MONITORING YEAR 1 ANNUAL REPORT FINAL

SANDY BRANCH MITIGATION SITE

RE: Monitoring Year 1 Report Sandy Branch Mitigation Site, DMS ID# 100060
Cape Fear River Basin – CU# 03030003
Chatham County, North Carolina
Contract No. 7527

MY1 Report – Stream Mitigation

Recorded Bankfull Events

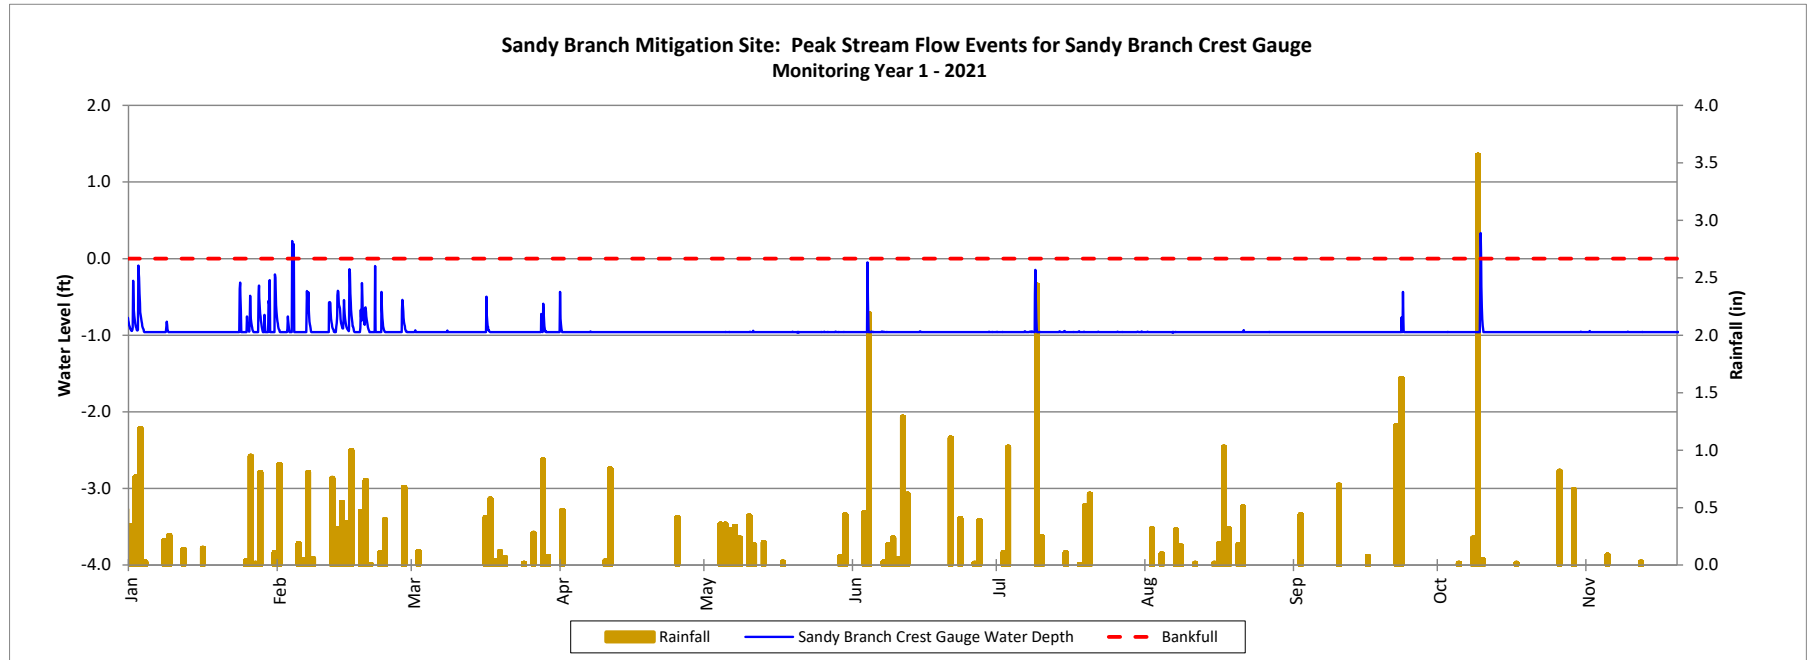
2. A figure should be included in the report illustrating a time series for the crest gauge data and indicating the occurrence of the bankfull events listed in Table 10. Please also collate these raw data and submit them as a single workbook with the figure included.

A figure illustrating a time series for the crest gauge data and indicating the occurrence of bankfull events was added to Appendix D and included in the digital submittal.

Soil Temperature Probe Plot

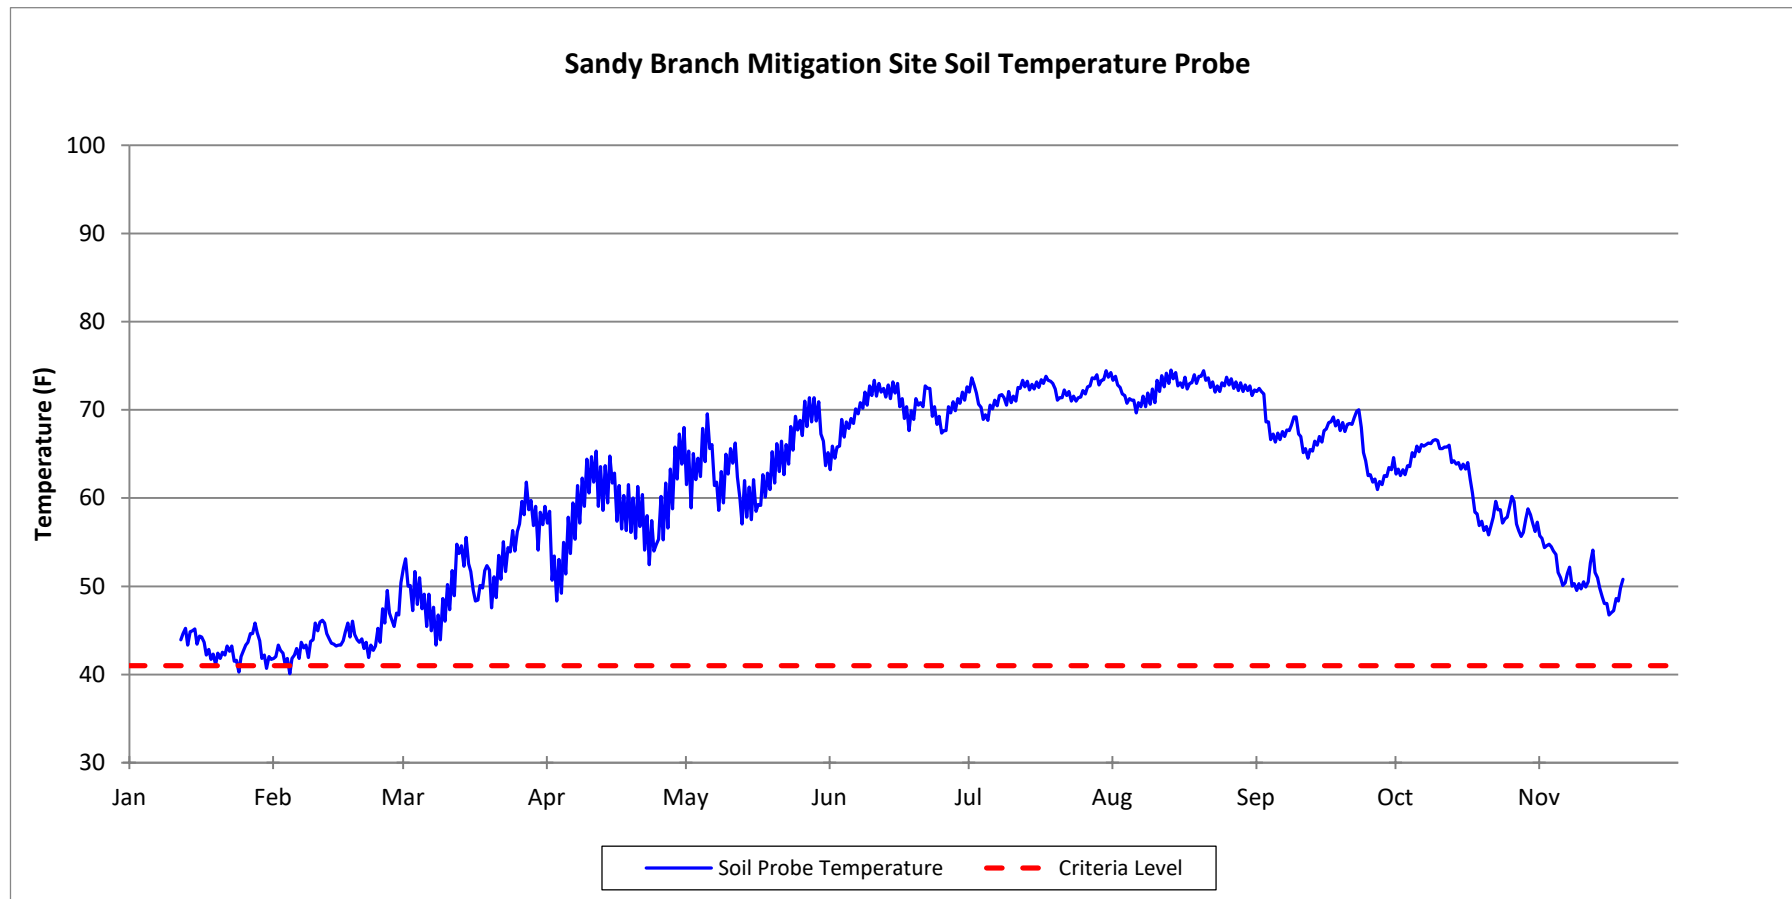
1. The soil temperature figure should be included in the report and if budburst photos are available these should also be included in the report and digital submittal.

The soil temperature figure was added to Appendix D and included in the digital submittal. No budburst photos are available.
